March 15, 2018)

**Cheryl Moon Siriani, District Executive  
Penn DOT, District #11, Thoms Run Road  
Bridgeville, Pa. 15017**

**To Cheryl Moon Siriani :**

## **THE FOLLOWING FACTS SEEM TO SUGGEST A RE- CONSIDERATION OF CONSTRUCTING THE LEFT TURN STACKING LANE**

NEW STATE AND COUNTY ROADS  
BUILT TO THE UPPER ST. CLAIR & MT.  
LEBANON BUSINESS DISTRICTS.

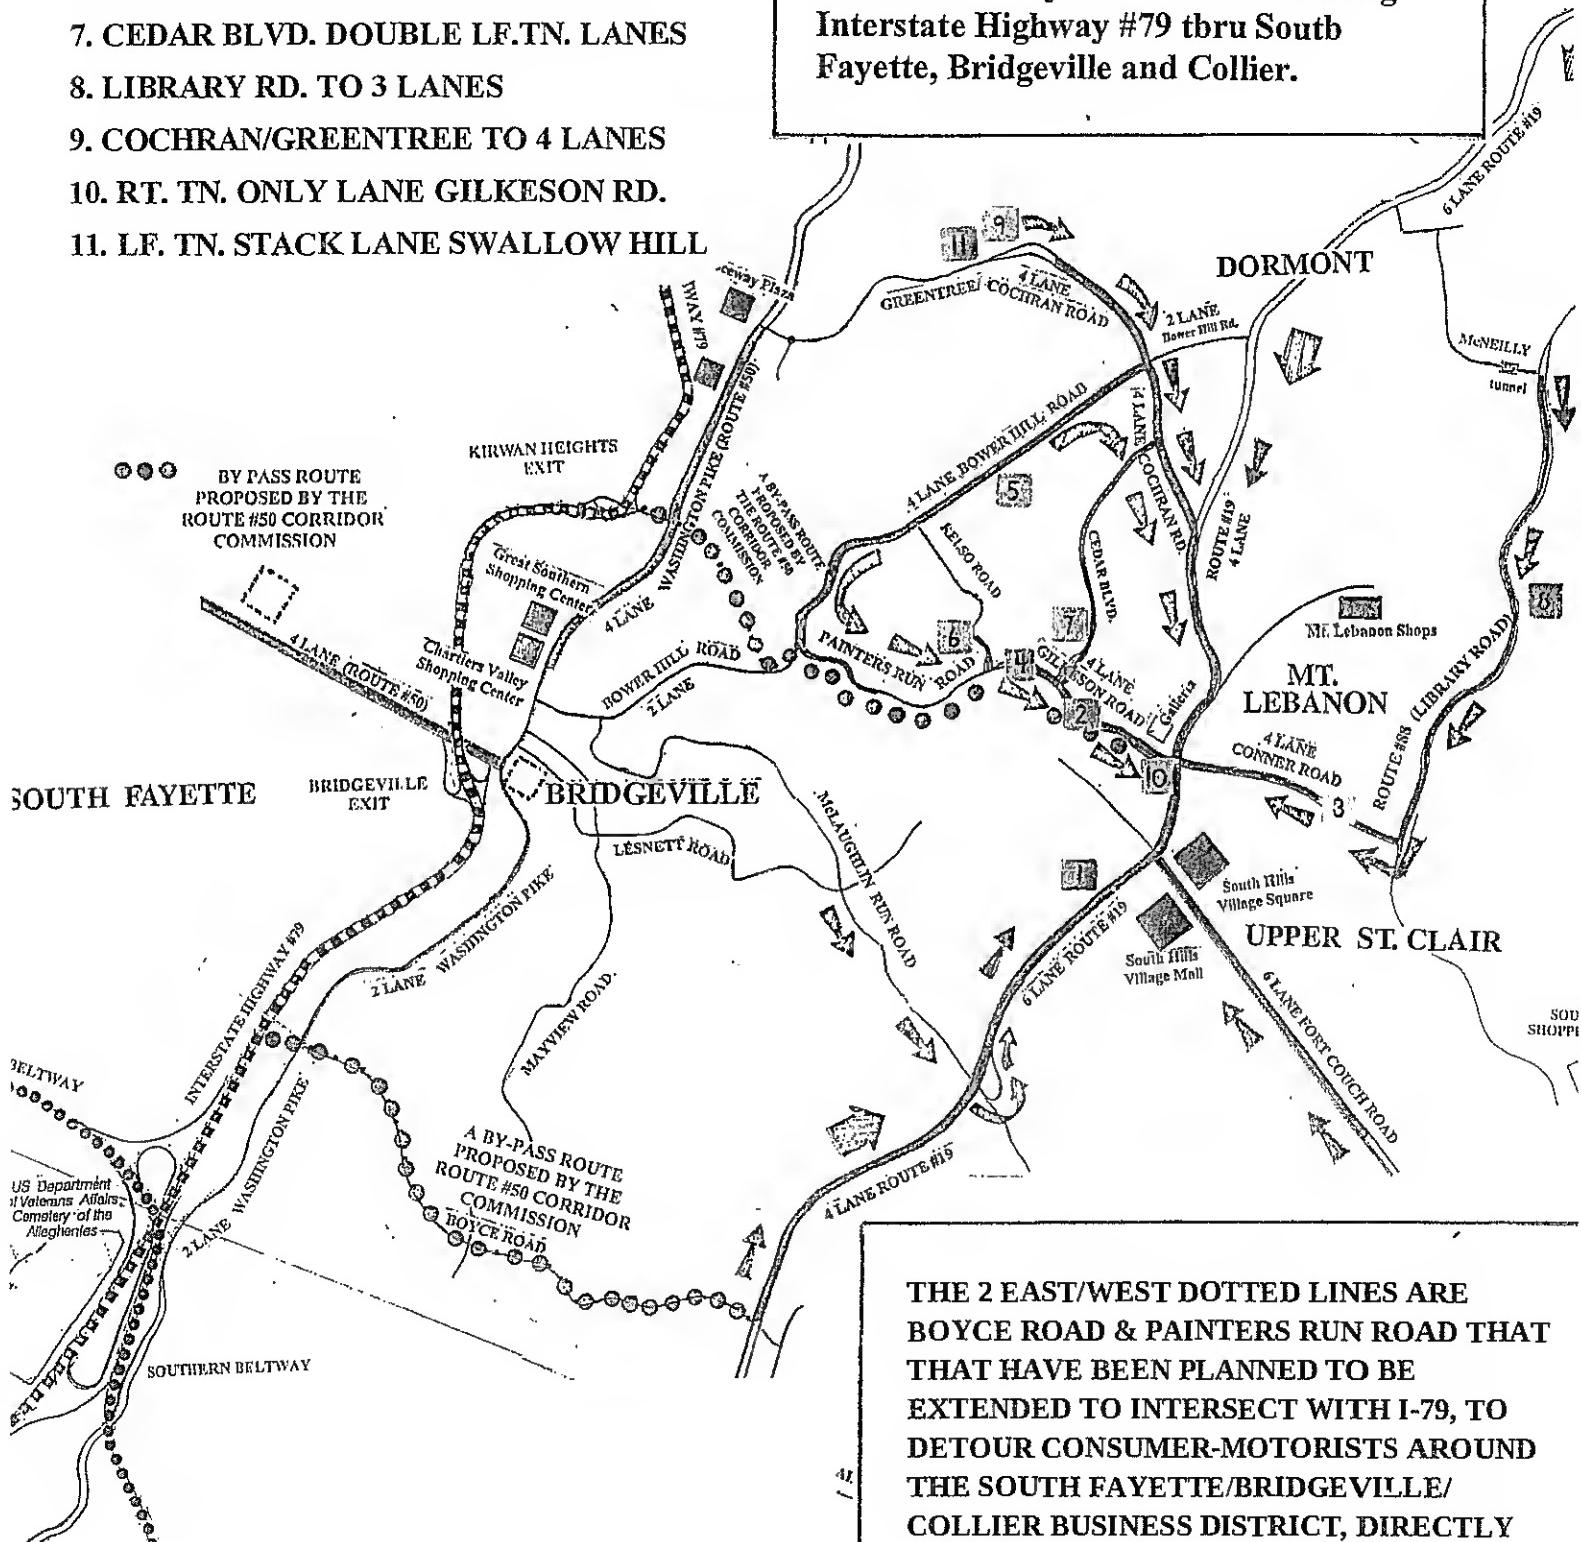
- 1. ROUTE #19 WIDENED TO 6 LANES**
  - 2. GILKESON RD. TO 4 LANES**
  - 3. CONNER RD. 4 LANES**
  - 4. GILKESON RD. 1/2 MORE 4 LANES**
  - 5. BOWER HILL RD. TO 4 LANES**
  - 6. KELSO RD. LF.TN. STACK LANE**
  - 7. CEDAR BLVD. DOUBLE LF.TN. LANES**
  - 8. LIBRARY RD. TO 3 LANES**
  - 9. COCHRAN/GREENTREE TO 4 LANES**
  - 10. RT. TN. ONLY LANE GILKESON RD.**
  - 11. LF. TN. STACK LANE SWALLOW HILL**

The RED colored roads are the network of 6 four lane wide roads the State and the County built leading to the Upper St. Clair/Mt. Lebanon Route #19 business district,

despite the fact that 75% of motorists stopped using Route #19 to get to and from Pittsburgh each day,

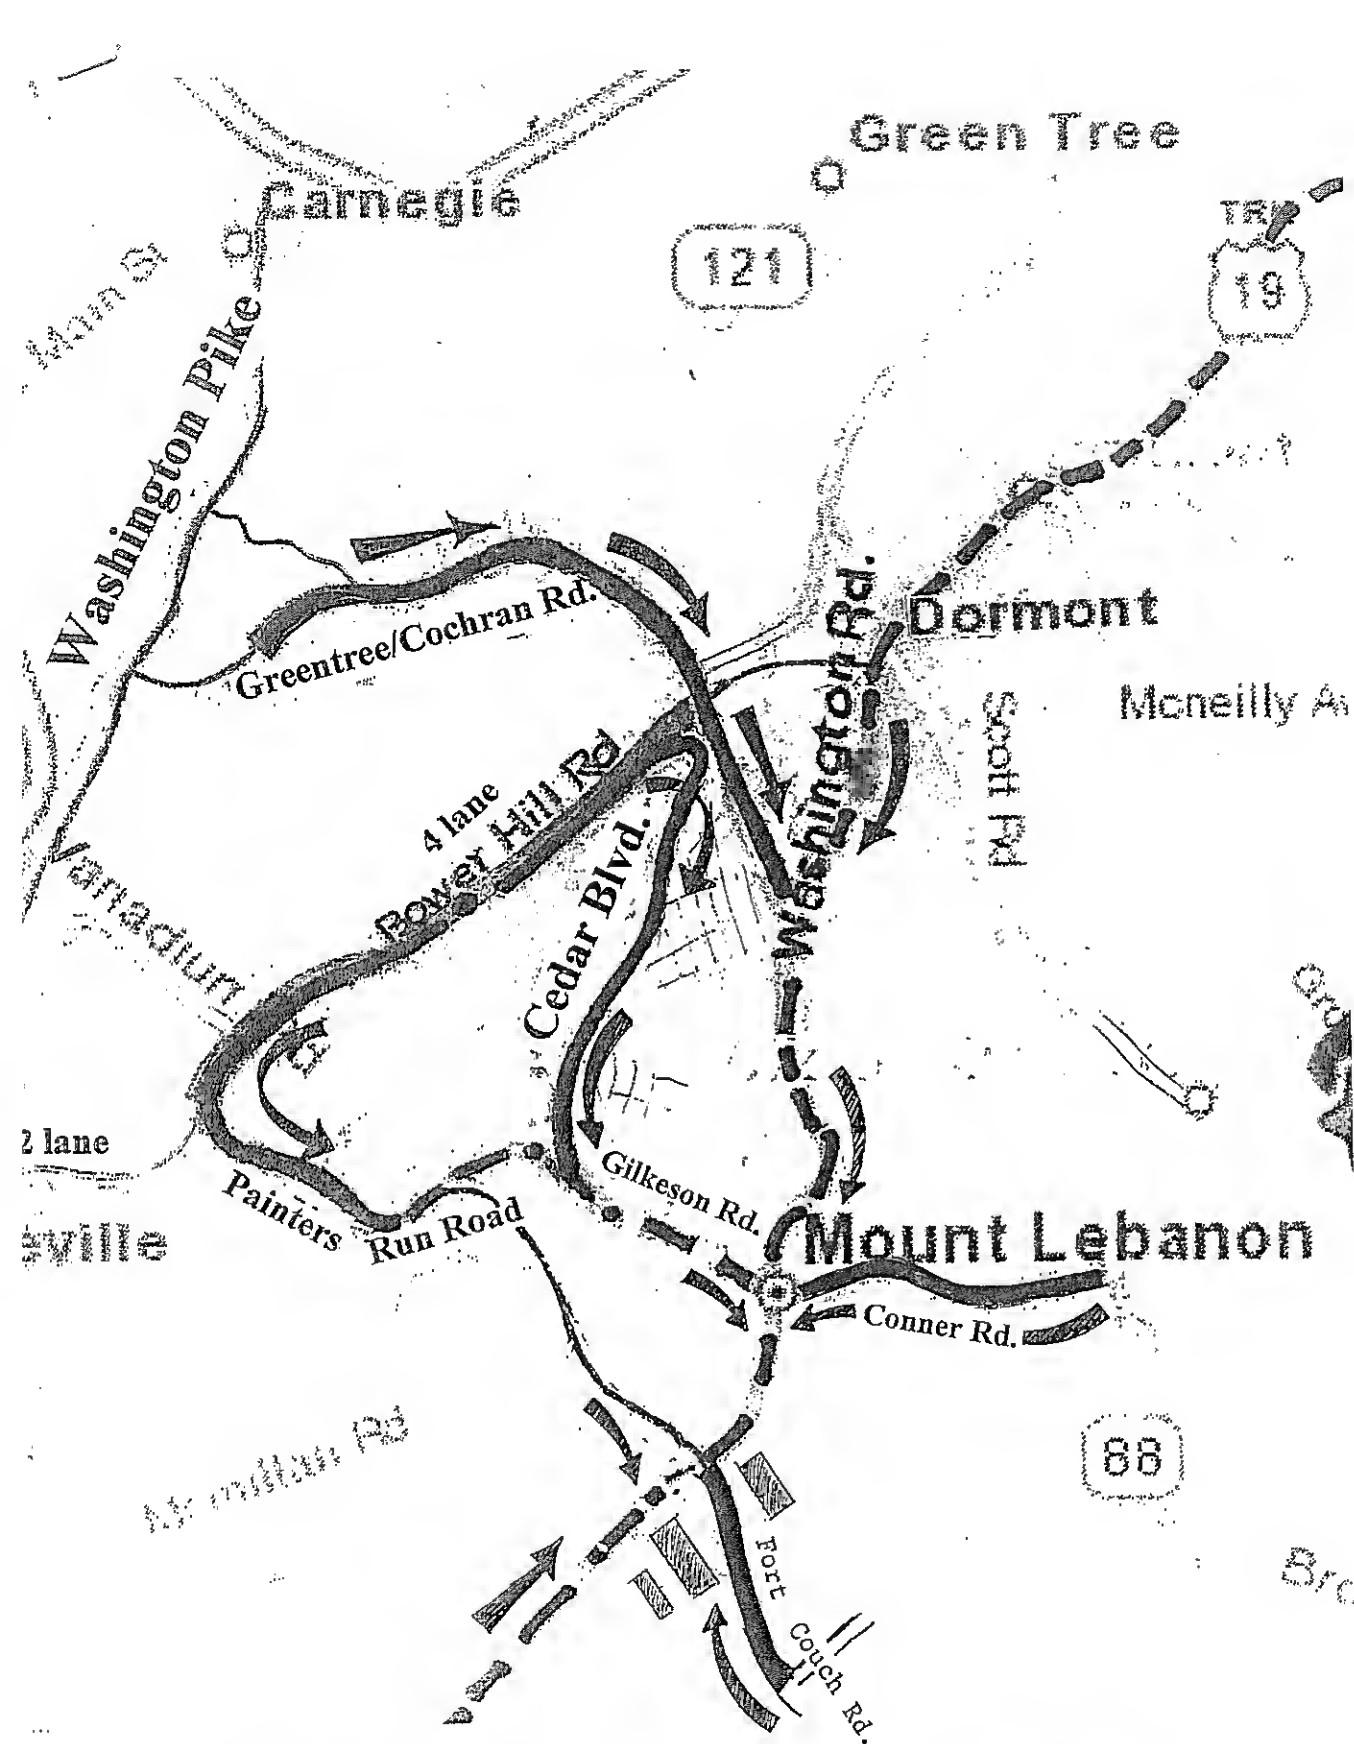
THE 2 EAST/WEST DOTTED LINES ARE  
BOYCE ROAD & PAINTERS RUN ROAD THAT  
THAT HAVE BEEN PLANNED TO BE  
EXTENDED TO INTERSECT WITH I-79, TO  
DETOUR CONSUMER-MOTORISTS AROUND  
THE SOUTH FAYETTE/BRIDGEVILLE/  
COLLIER BUSINESS DISTRICT, DIRECTLY  
TO THE ROUTE #19 BUSINESS DISTRICT.

SHOWN IS HOW THE 4 LANE WIDENING OF BOWER HILL ROAD WAS NEVER CONTINUED TO THE DORMONT BUSINESS DISTRICT, NOR IN THE OPPOSITE DIRECTION TO THE BRIDGEVILLE, COLLIER, SOUTH FAYETTE BUSINESSSS DISTRICT, IN ORDER TO LEAD CONSUMER MOTORISTS TO THE ROUTE #19 BUSINESS DISTRICT.

# The PROBLEM

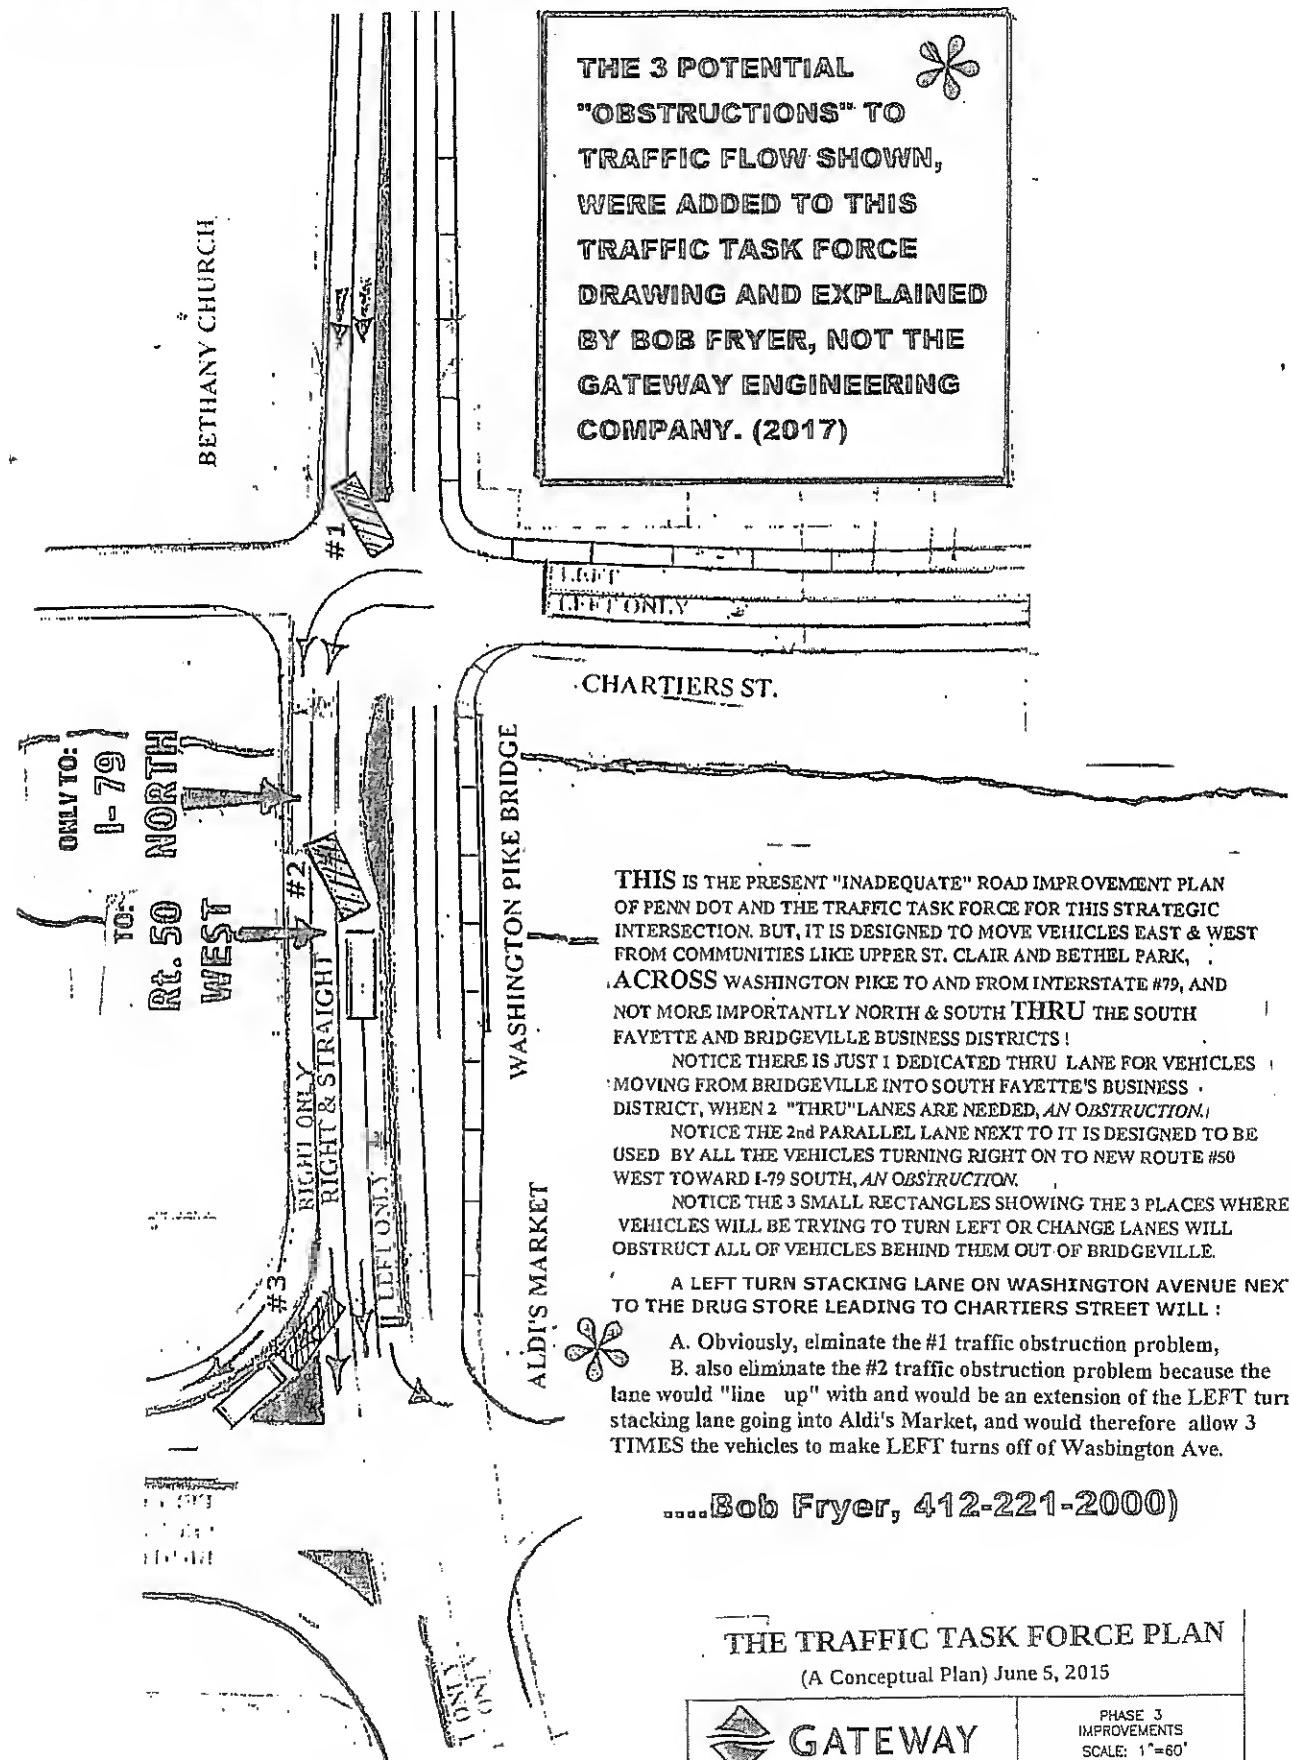
1. The new bridge will only have 1 Washington (Pike) Ave. lane dedicated exclusively for consumer-motorists from Bridgeville to enter South Fayette's central business district,
2. that there would be vehicles not able to "get completely into" the right lane on the bridge for vehicles moving to Route #50 West and I-79 South, that would block the 1 lane into the South Fayette central business district and
3. that there would be vehicles not able to "get completely into" the left turn stacking lane (on the bridge) leading to the Aldi Store shopping center, that would ALSO block the 1 lane into the South Fayette central business district from Bridgeville. SEE DRAWING.

This **1** Southbound lane can (and will) ALSO be periodically blocked by vehicles trying to get into the Route #50 West bound lane next to it, that have to stop before they are completely into the Route #50 West bound lane. SEE DRAWING.

This means that some of these vehicles waiting to turn left will also be stopped before they are completely into the left turn stacking lane, and will ALSO block the 1 lane from Bridgeville into South Fayette's business district!

# PROBLEM

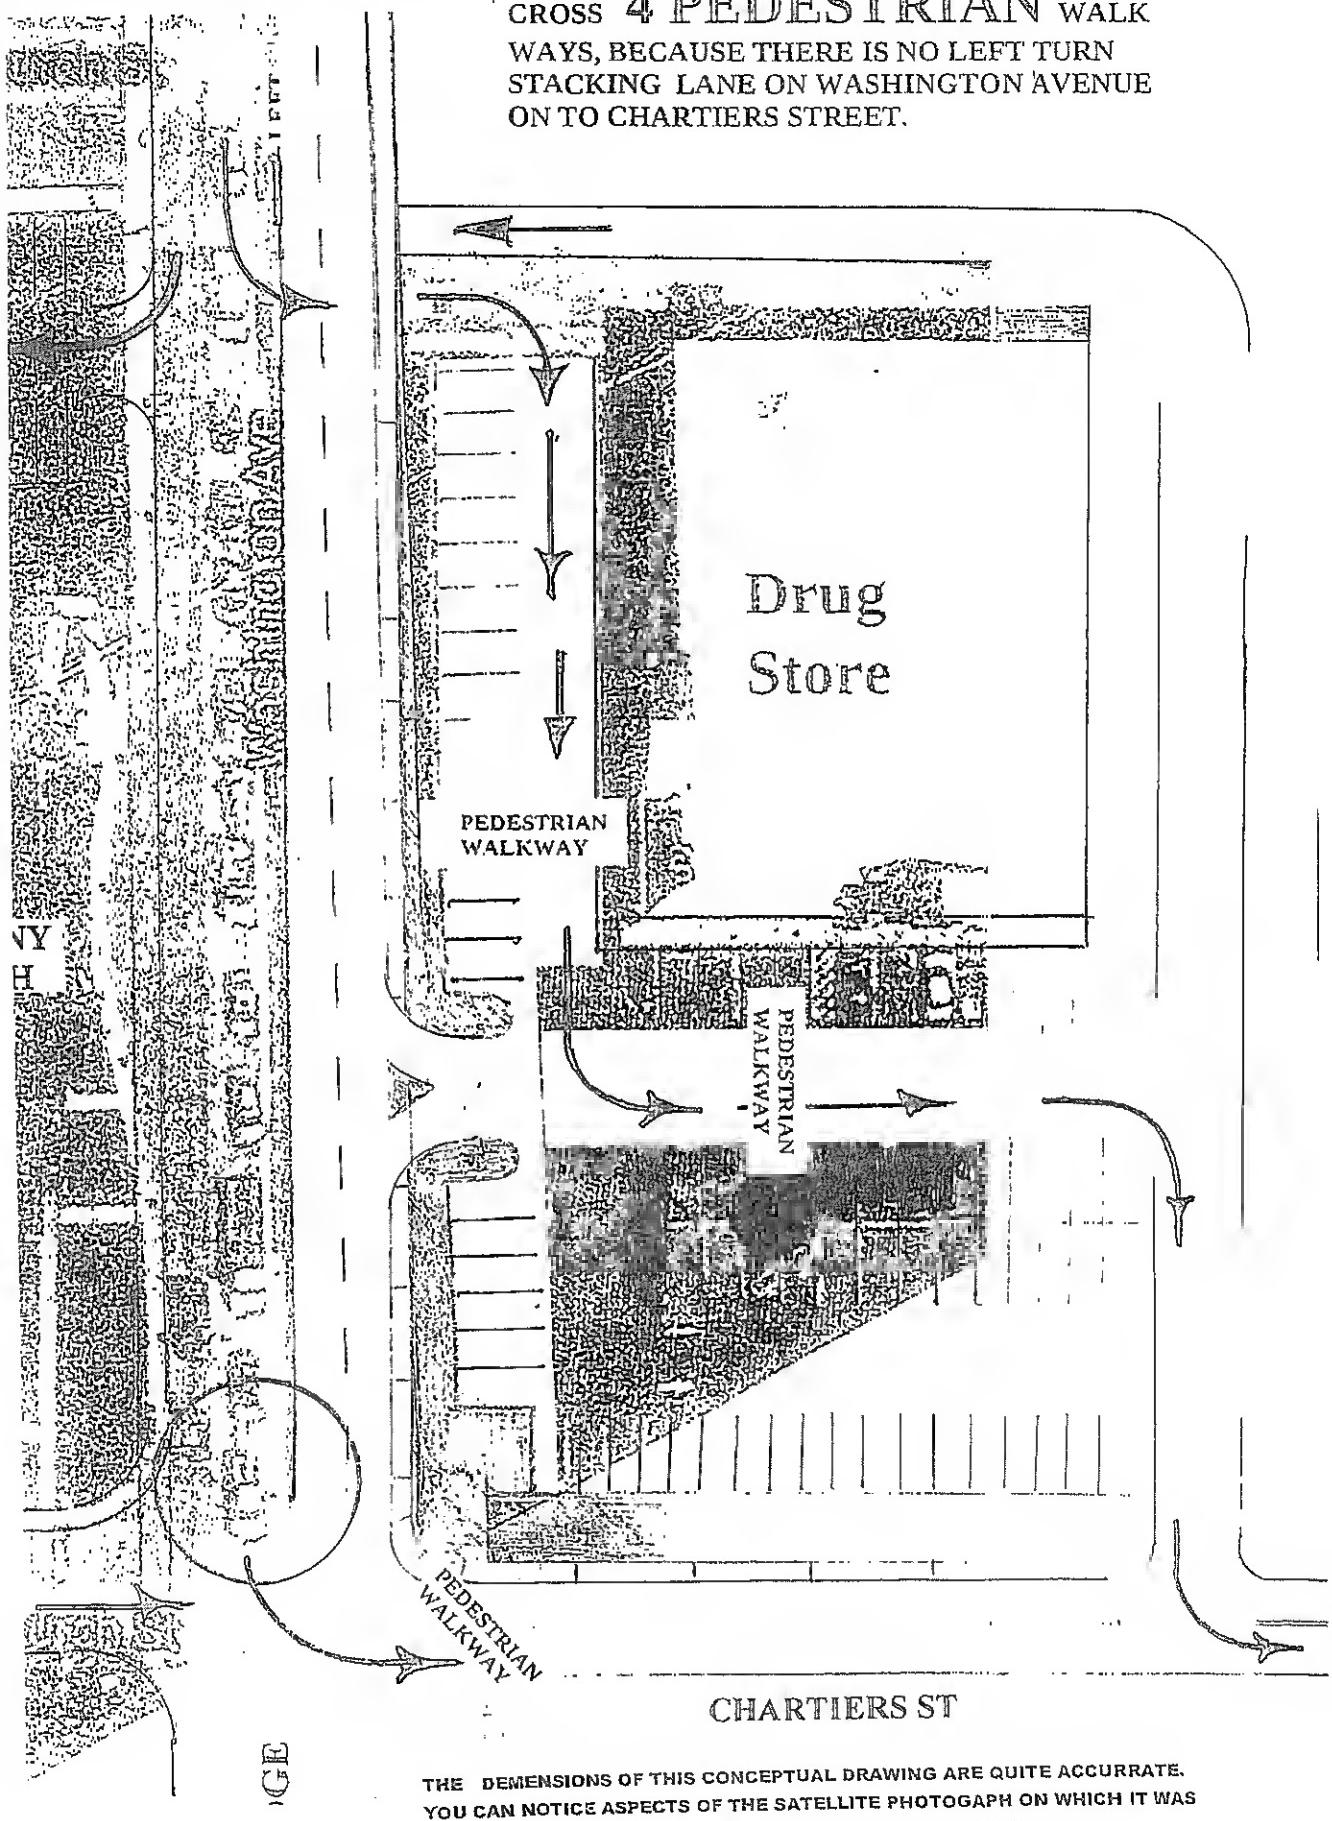
SHOWN ARE THE DANGEROUS OPTIONAL ROUTES MOTORISTS HAVE DEVISED THAT

CROSS 4 PEDESTRIAN WALKWAYS, BECAUSE THERE IS NO LEFT TURN STACKING LANE ON WASHINGTON AVENUE ON TO CHARTIERS STREET.

Also, during our two 1 hour traffic counts, 3 additional Southbound vehicles on Washington Ave. turned RIGHT to drive around the Betheny Church thru its parking lot and in front of its rear door, to avoid the delay in turning left at the intersection, so they could then come up along side the Church St. and drive **ACROSS** Washington Ave. to Chartiers Street.

Also, 2 of the Southbound vehicles on Washington Ave. turned LEFT thru the drug store parking lot, to avoid waiting to turn left at the traffic light to Chartiers St. When the Rite-Aid officials visited the site last month, they witnessed the cars dangerously cutting thru their parking lot, in front of their main customer entrance.
